LAKE MENDOTA DRIVE ASSESSMENT DISTRICT - 2024

ADD1	DETAIL DESIGN & NOTES UPDATE	02/19/2024	BAO
MARK	REVISION	DATE	BY
1	DESIGNED BY: AJC	DATE: 2/20/2024 12:05 PM	Scale: ###
14083			D-3

NORMAN WAY - ENDWALL DETAIL
 LAKE MENDOTA DRIVE ASSESSMENT DISTRICT - 2024
 M:\DESIGN\Projects\14083\CAD\sewers\14083SWR-PnP.dwg

* ADDENDUM 1 - 02/19/2024 DAO

NORMAN WAY (PARKS-SPRING HARBOR PARKING) - SEWER PLAN & PROFILE

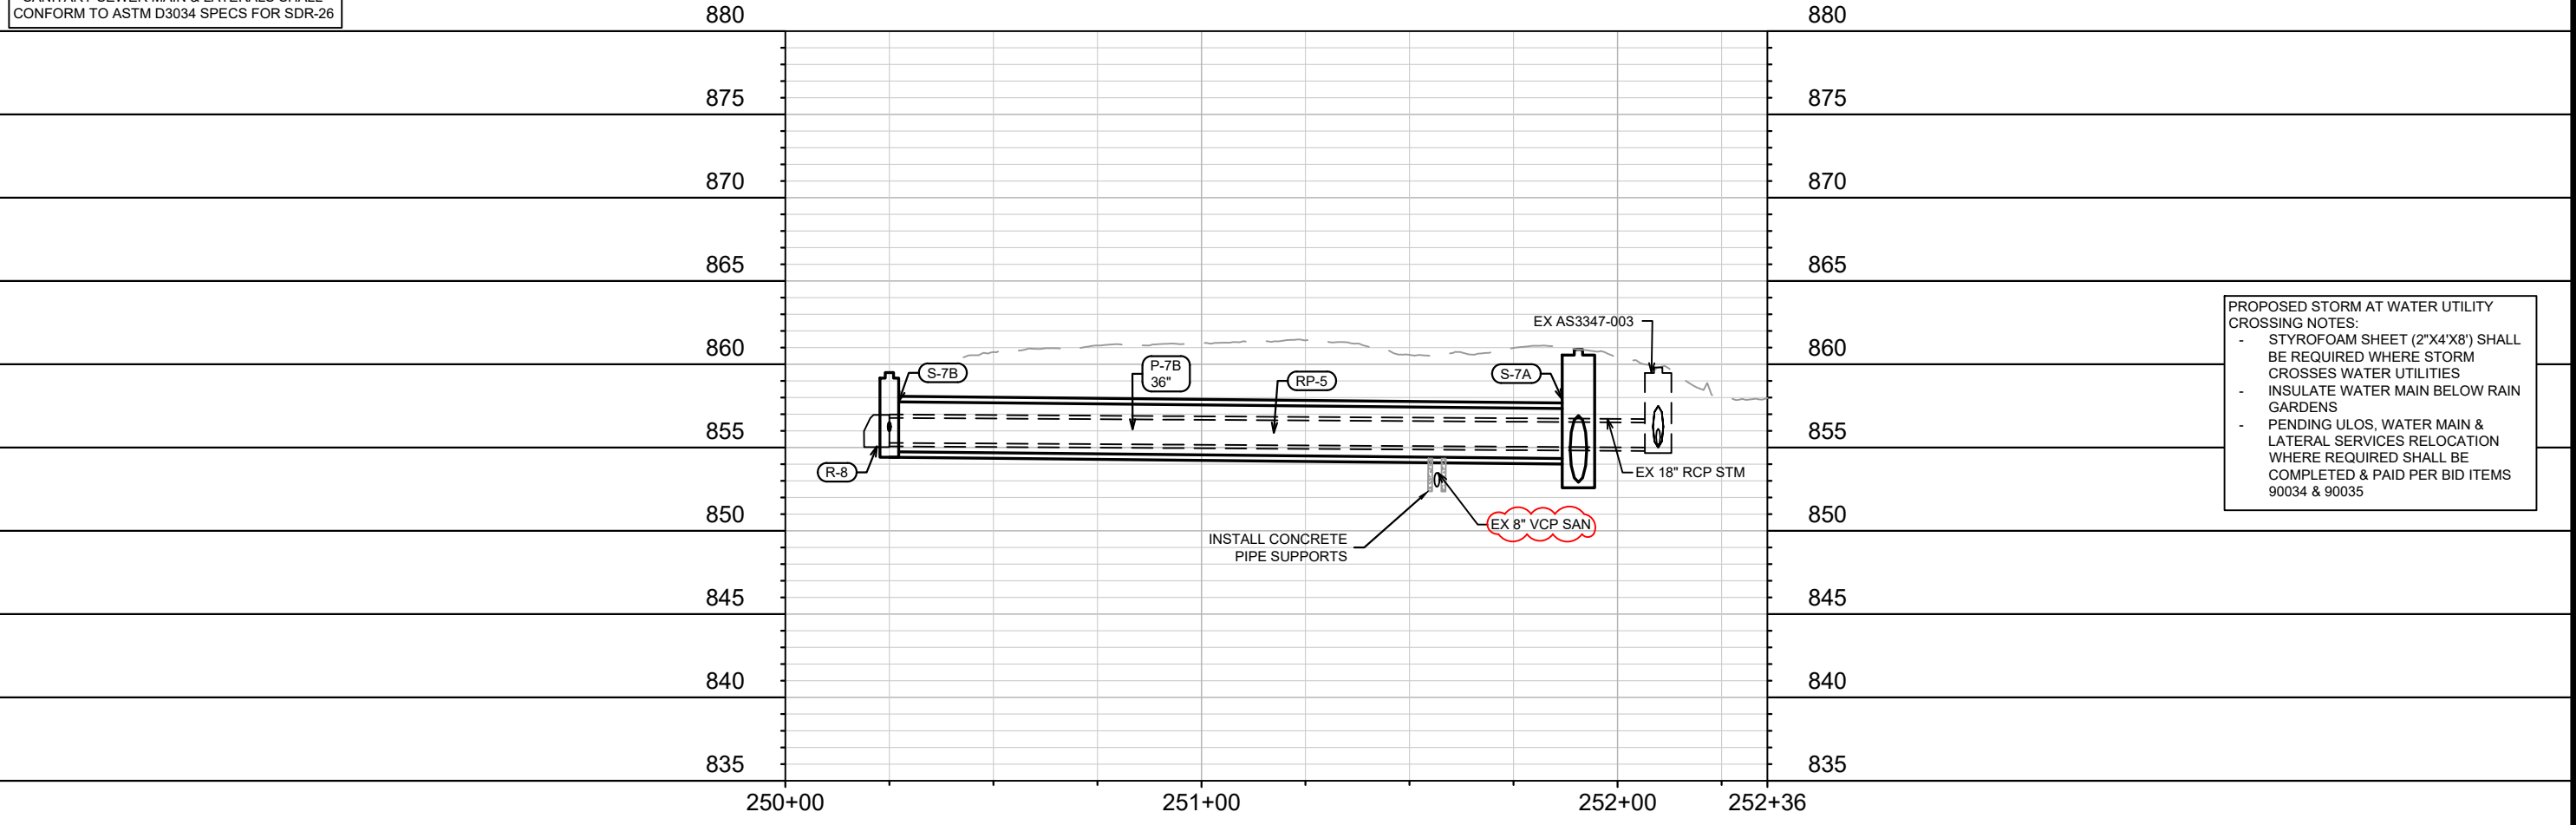
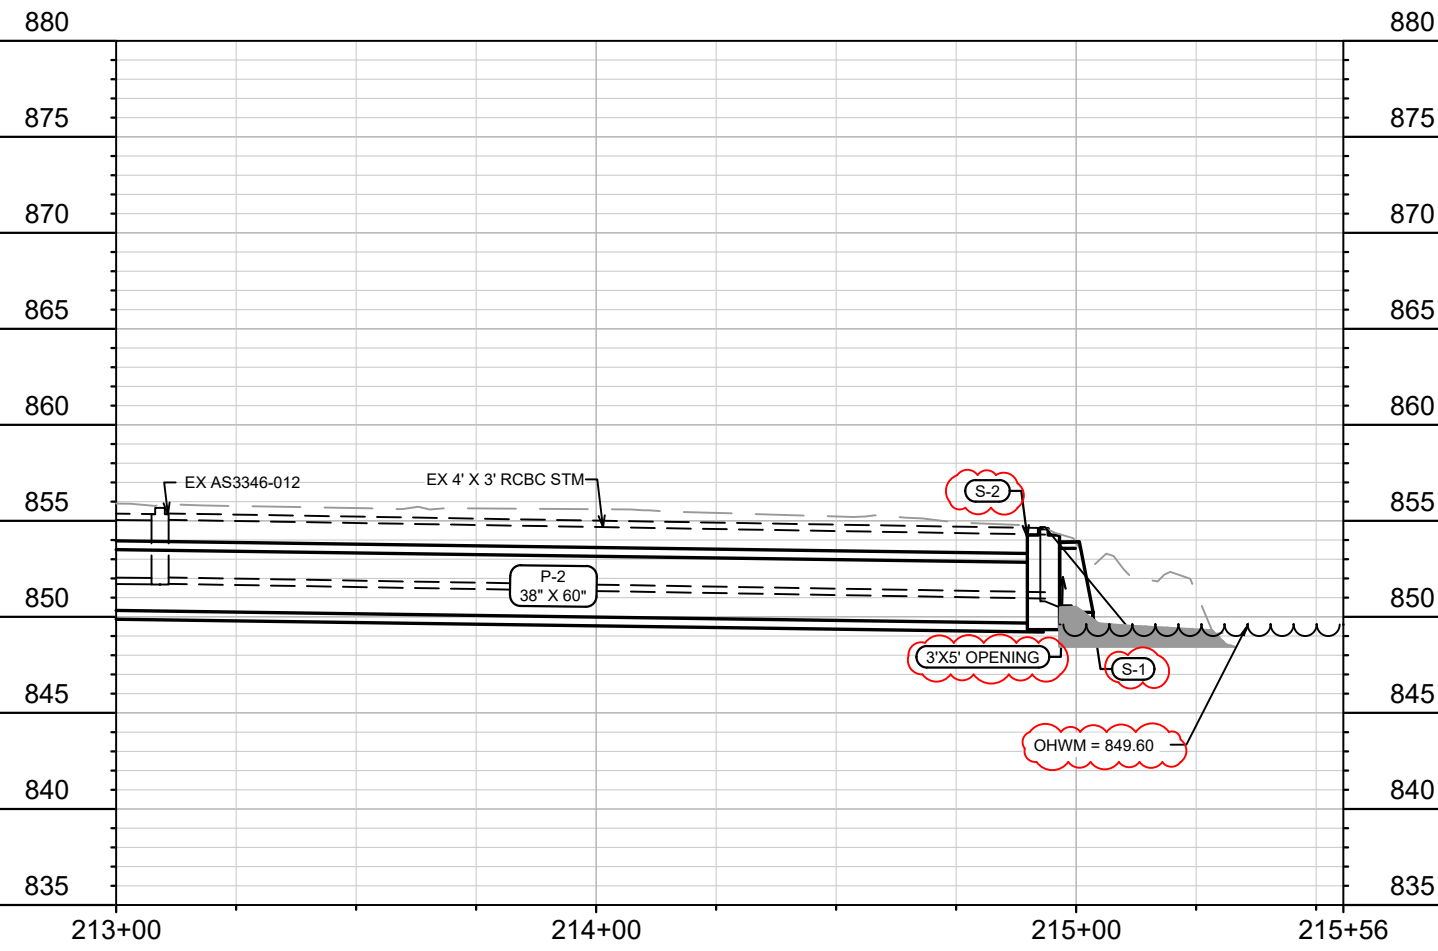
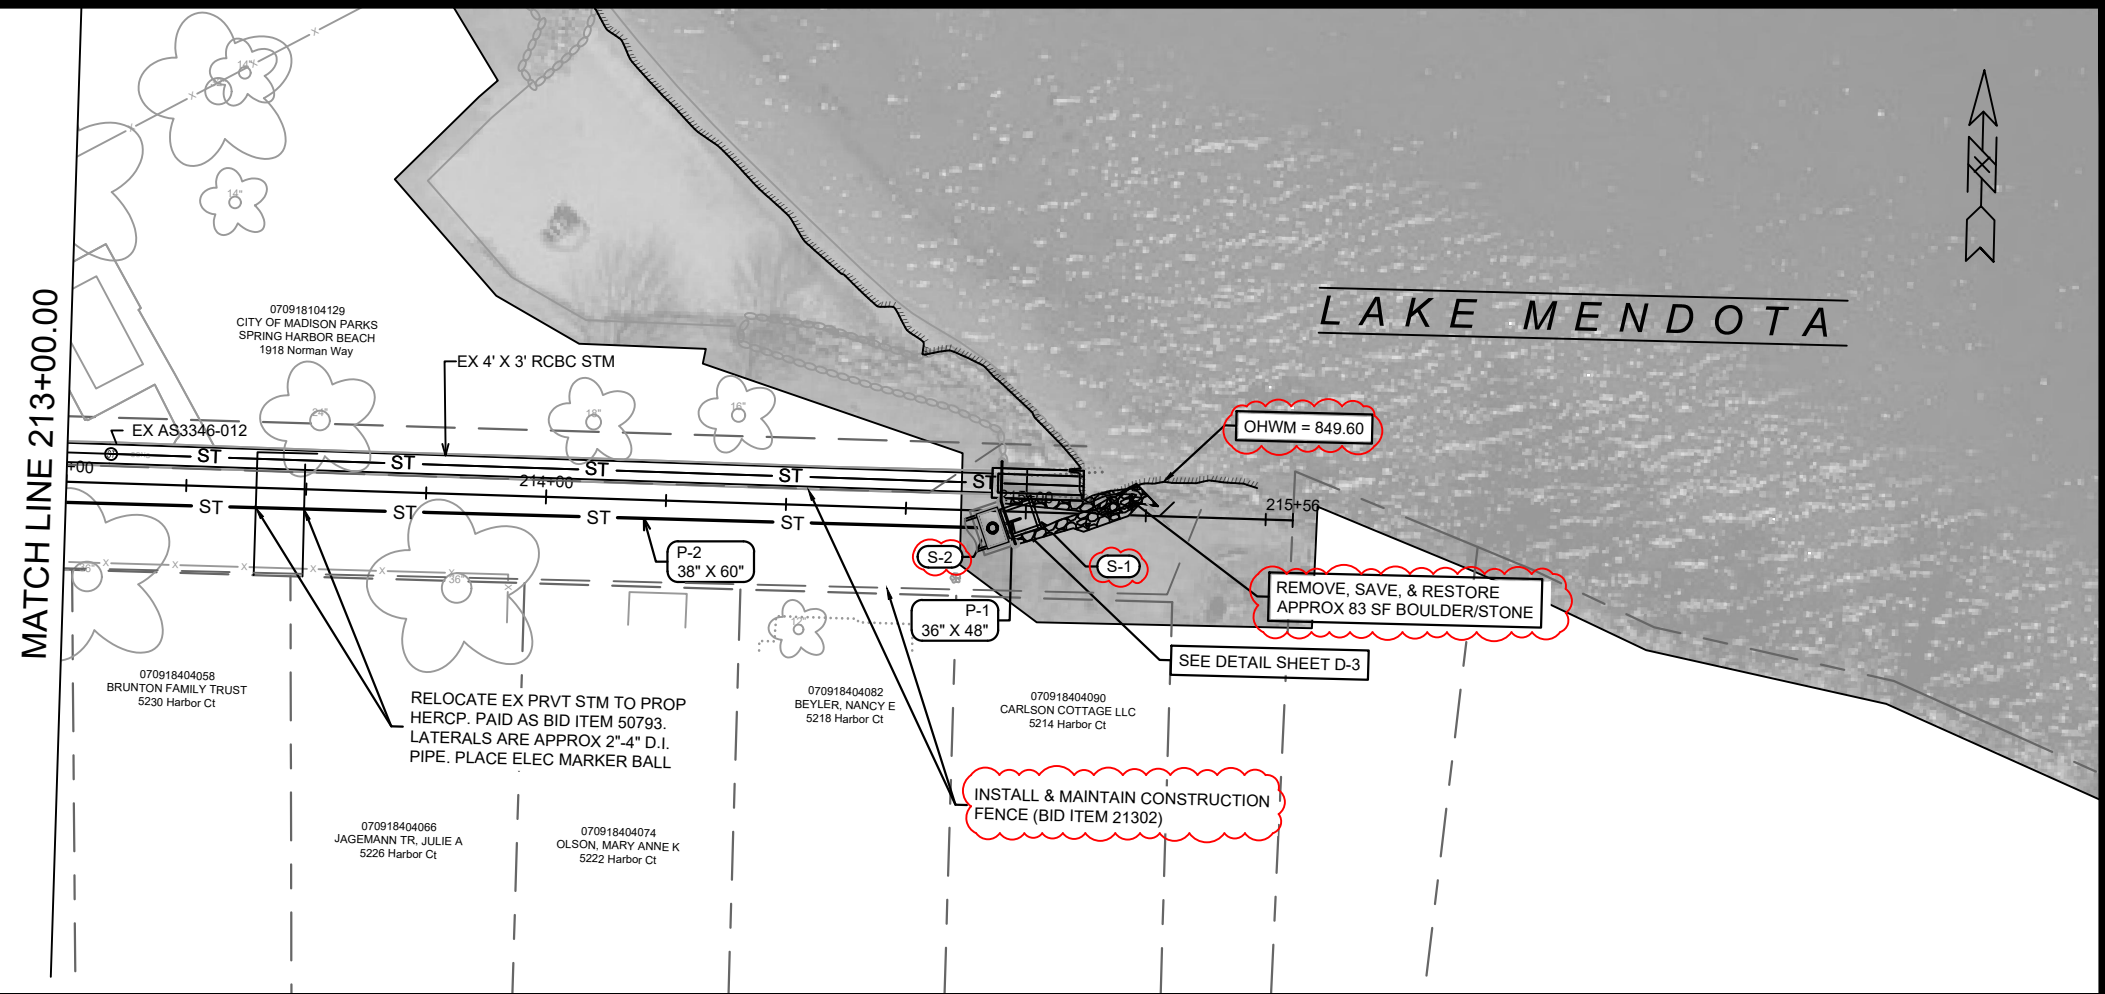
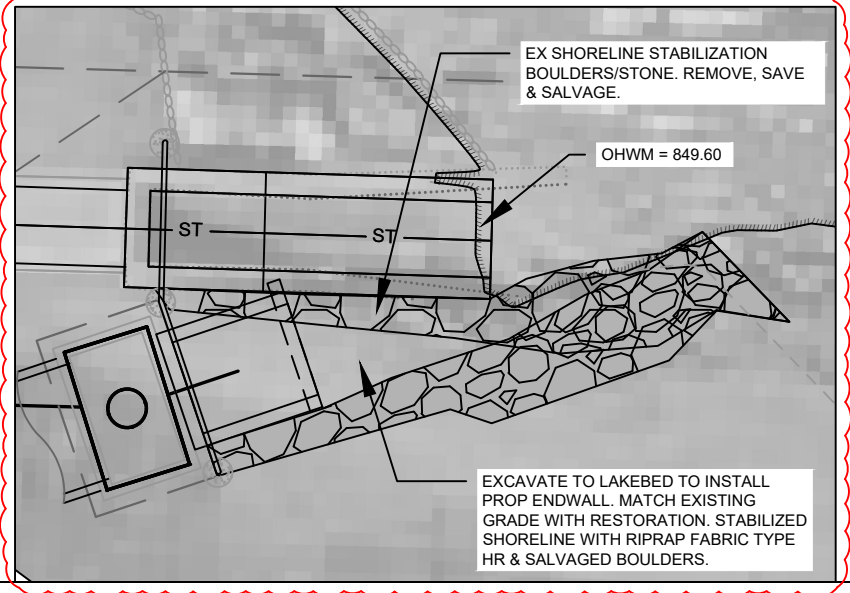
DATE	BY	U-5
02/19/24	DAO	
REVISION	DATE	Scale: 1" = 40'
UPDATE NOTES	2/20/2024 12:05 PM	
MARK	DESIGNED BY: AJC	14083

INSTALL CONSTRUCTION FENCING AROUND WORK AREA UNTIL RESTORED (BID ITEM 21302). MINIMIZE WORK & DISTURBANCE AREA. DO NOT STOCKPILE OR STORE MATERIALS WITHIN PARKS LOT. STOCKPILES W/ PERIMETER CONTROLS WITHIN ROW ARE OK.

INSTALL EXTERNAL JOINT WRAP ON ALL PROPOSED SANITARY SAS

PROPOSED STORM AT WATER UTILITY CROSSING NOTES:

- STYROFOAM SHEET (2"X4'X8') SHALL BE REQUIRED WHERE STORM CROSSES WATER UTILITIES
- INSULATE WATER MAIN BELOW RAIN GARDENS
- PENDING ULOS, WATER MAIN & LATERAL SERVICES RELOCATION WHERE REQUIRED SHALL BE COMPLETED & PAID PER BID ITEMS 90034 & 90035
